# DEVELOPMENT MANAGEMENT COMMITTEE 18<sup>th</sup> JULY 2022

**Case No:** 20/00923/REM (APPROVAL OF RESERVED MATTERS)

**Proposal:** RESERVED MATTERS APPLICATION FOR 25 DWELLINGS FOR ACCESS, APPEARANCE, LANDSCAPING, LAYOUT AND SCALE PURSUANT TO OUTLINE PLANNING PERMISSION 17/00101/OUT

**Location:** D J C PRODUCE PINGLE BANK, HOLME. PE7 3PJ

PROJECT		
Proposed residential development, Pingle Bank, Holme, Peterborough		
CLIENT		
NJC and Sons Farms Limited		
DRAWING TITLE		
Highway Improvement Plan - North		
DRAWN	DJM	SCALES 1:200 @ A0
DATE	16/06/22	DWG. No. 10/07/F1
		REV.

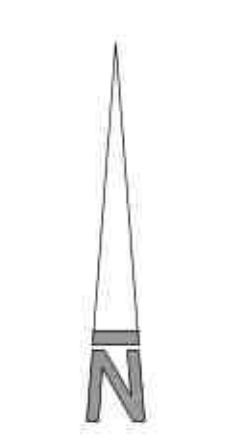
The crossing over the southern end of Pingle Bank needs to be well defined, ideally zebra marked and lit, and not compromising the driveway where it has been drawn on the plan.

There are no measurements on the plan. The proposed crossing appears to be about 30m from the junction but this is too short a distance to comply with regulations on this busy road.

As planned the crossing point is far too close to the bend. Drivers coming from the east would not be able to see pedestrians until last minute (at the apex of the bend) making it difficult for them to slow down in time. During the winter months the issues surrounding this crossing would be compounded by the dark and possibly bad weather.

- a. **Position:** The crossing shown is far too close to the bend of Station Road. The MfS indicates at Chapter 7.5 that the stopping distance at 30mph is 40m (43m with bonnet length included). The crossing is situated 9.0 metres east from the edge of the driveway to the bungalow "Winsbury" according to a dimensioned plan from the developer I have been sent and the proposed site for the crossing point is therefore much less than 40m away from the apex of the bend. The crossing point is **definitely not safe** at this point and the Council **objects strongly** to this siting.
- b. Please refer to the Speed Indicator Device records submitted regularly to Cambs Highways (document B attached) which show that the V85 figure for this area of station road is 32mph - core data can be provided on demand. The stopping distance would therefore be more than 40m.

“Crossing points indicated are not controlled crossing points but are suitable for the nature of the highway and numbers of pedestrians likely to use them. It would not be reasonable to request anything over that proposed and, therefore, doing so would fail the tests in planning terms. It would therefore not be possible to defend at any subsequent appeal.”

- 7.79 The proposed highway improvement scheme appears compliant with this guidance given the physical constraints of the swale.
- 7.80 The Local Highways Authority has assessed the latest highways arrangement plans and have concluded that they are acceptable in design terms, equal to or better than the existing highway arrangement, with crossing points suitable for the nature of the highway and numbers of pedestrians likely to use them. It is concluded that the arrangement will not compromise the safety

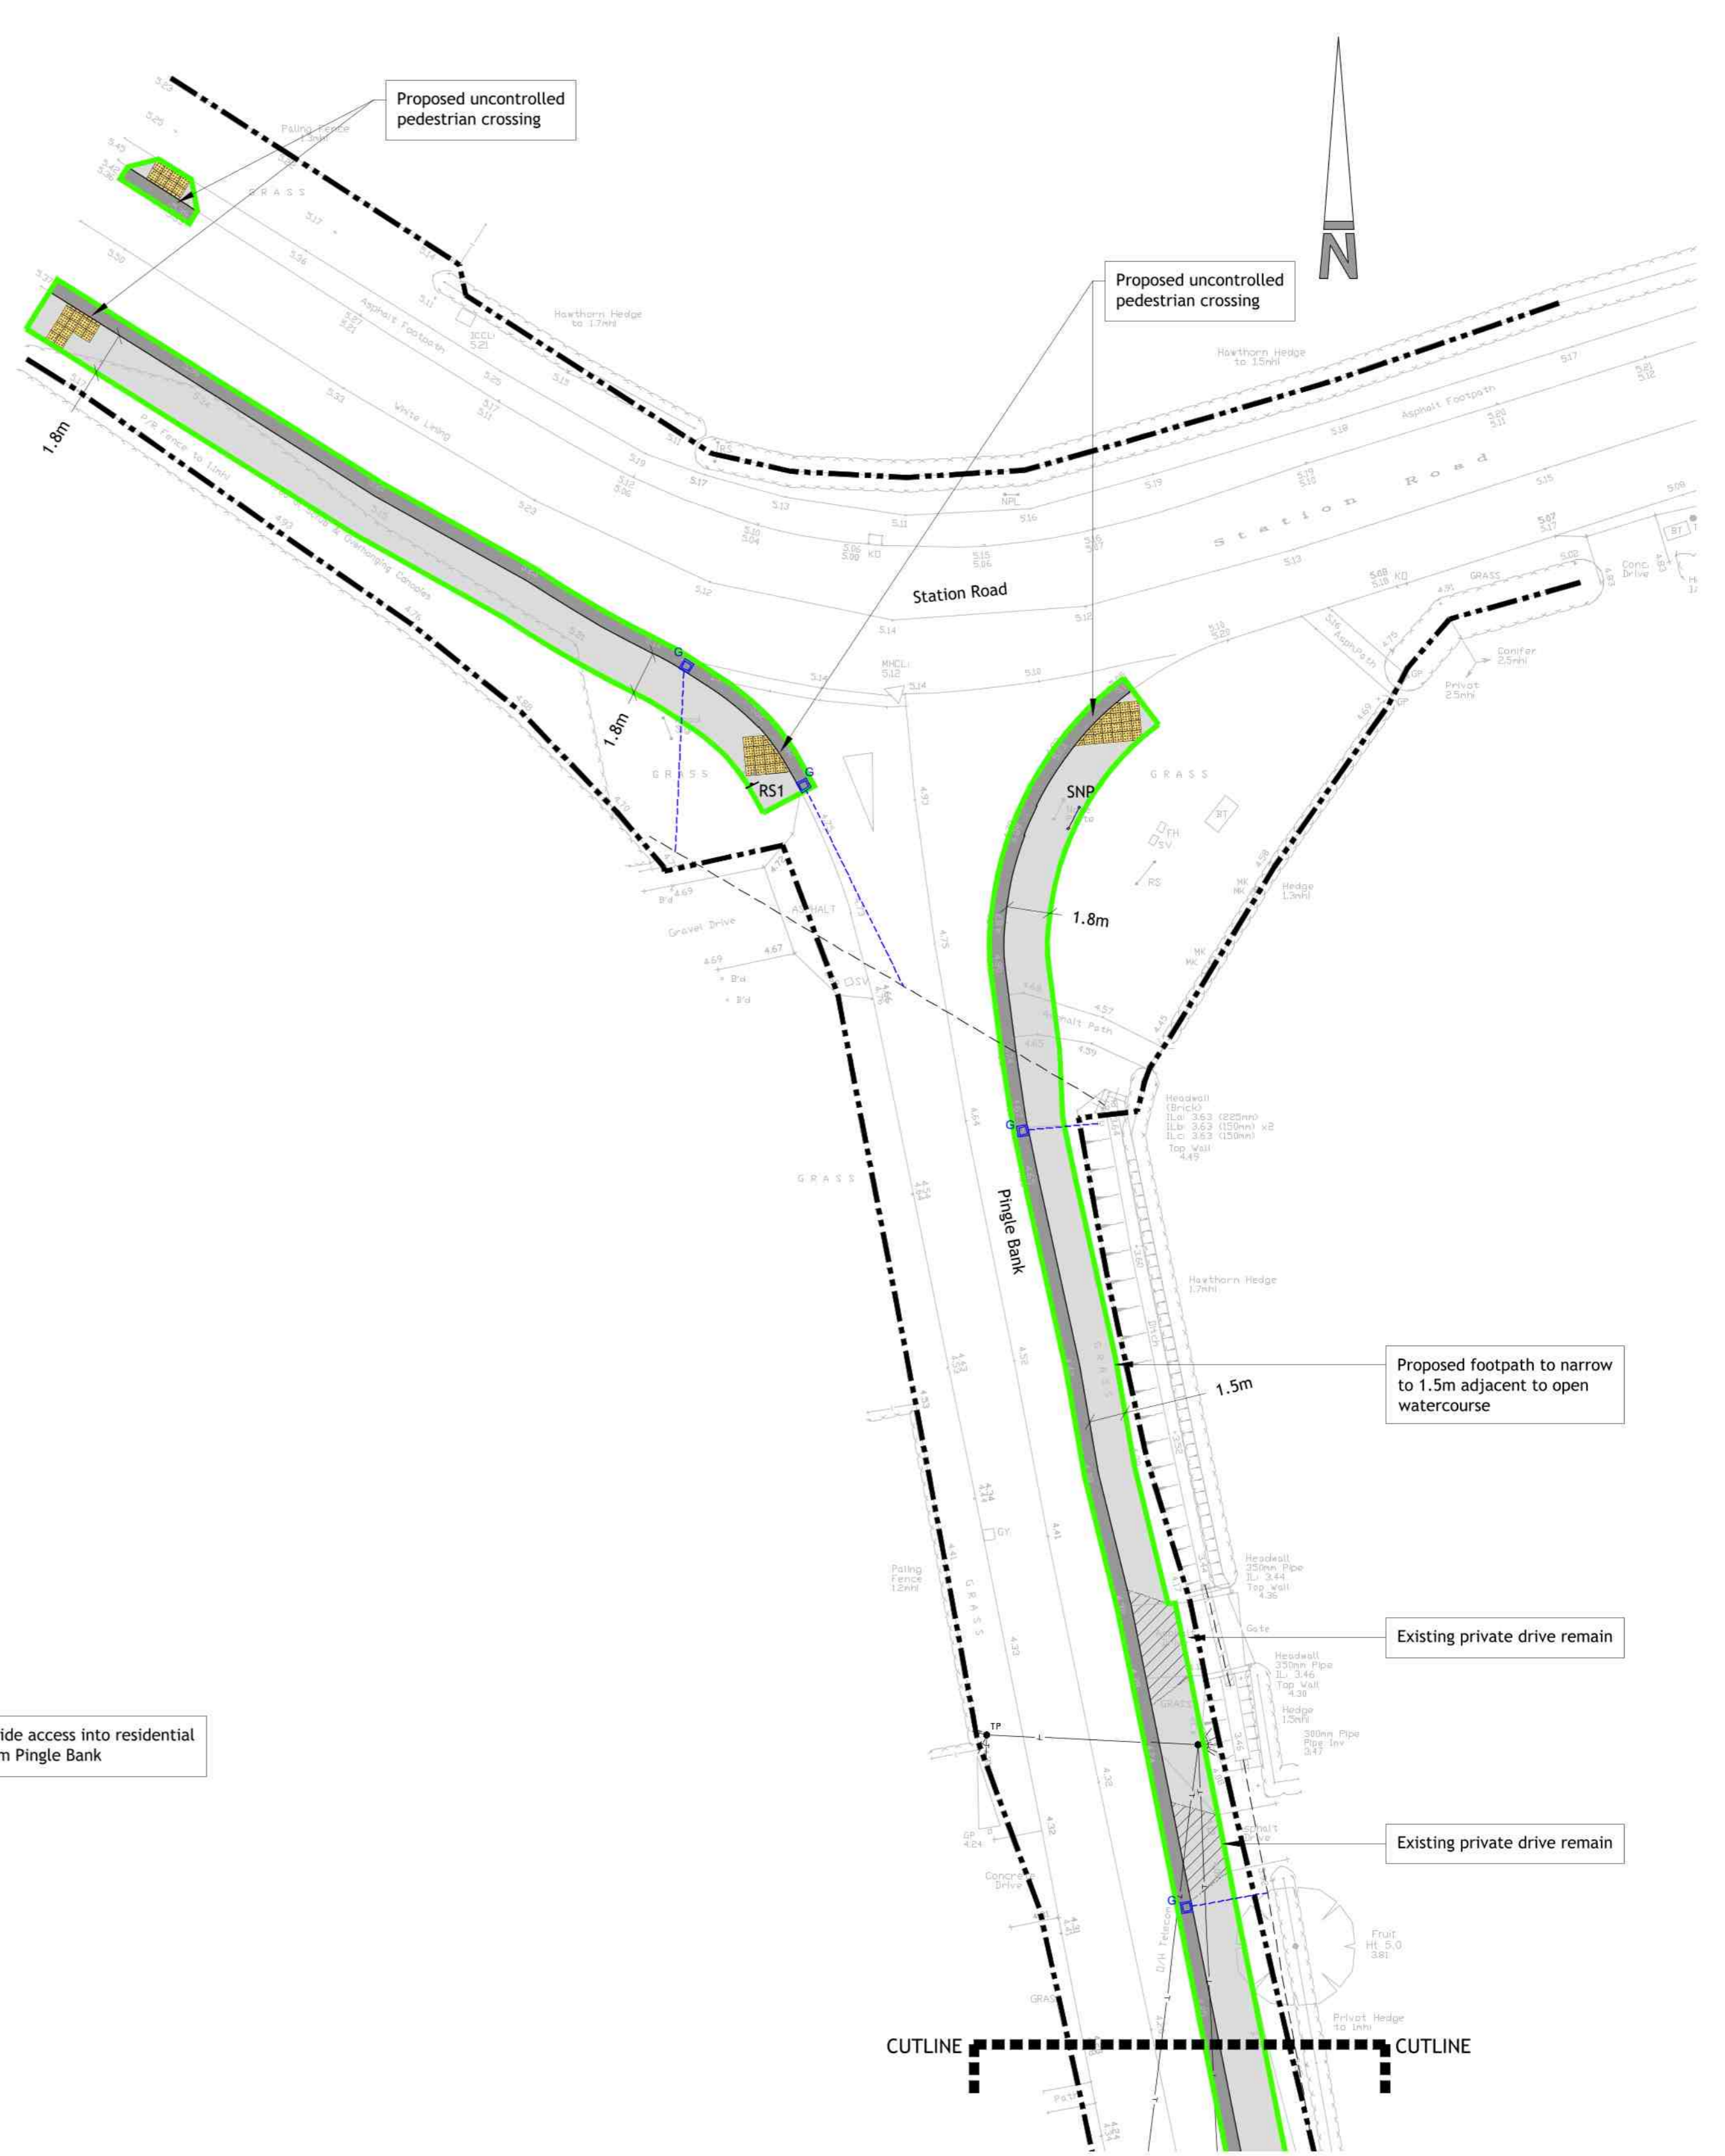
- a. As already stated in June 2021, the Huntingdonshire Design Guide (HDG) sets out the minimum road and footpath requirements. Pingle Bank could be classified as a Secondary Route. As such the road width needs to be a minimum of 5.5 m and the footpath 2m. Even if it were classified as a Tertiary Route, the road width should be 4.8m and footpath 2m. The new plans submitted still show a non-compliant 1.8 m footpath width, and the existing road (in particular where it narrows just by the start of the development site) is simply too narrow along most of its length to accommodate both a satisfactory road width and a suitable footpath. The new proposal does nothing to improve this and the proposal is still considered unsatisfactory, showing road widths of 4.8m and 5.3m with a footpath of 1.8m, all contrary to the HDG recommendations.

- c. There are currently roadside parking spaces along the east side of Pingle Bank. The residents use these for parking and have done for many years and the road is indeed marked to show this as parking space. These spaces will be lost to accommodate the proposed footpath, leaving residents and visitors nowhere to park and they will probably park on the footpath making it unsafe and useless for its intended pedestrian use. Alternatively they will have to park in the road exacerbating the narrowness of the road and potentially this is harmful in terms of access for larger emergency vehicles, oil lorries, refuse collection and farm traffic as well as making turning in/out of driveways more difficult for all properties.

Regarding the revised highway improvement plans;  
“The proposal accords with the principle of the Outline consent, where the relative impact of vehicles for the existing (B8 Storage and Distribution) and the proposed (Residential) development was considered and accepted.
